Exhibit B to Earnest Money Contract Between Robert Paul Mims & Katherine Ellen Crooks (Buyers) and Unicus Developments 6 LLC (Seller) Pertaining to Property at 2816 Newman St, Houston, TX 77098

Seller commitment to address Exhibit A.

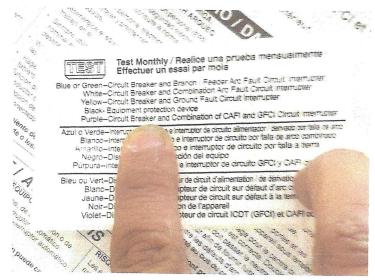
15. It has been completed (see picture)
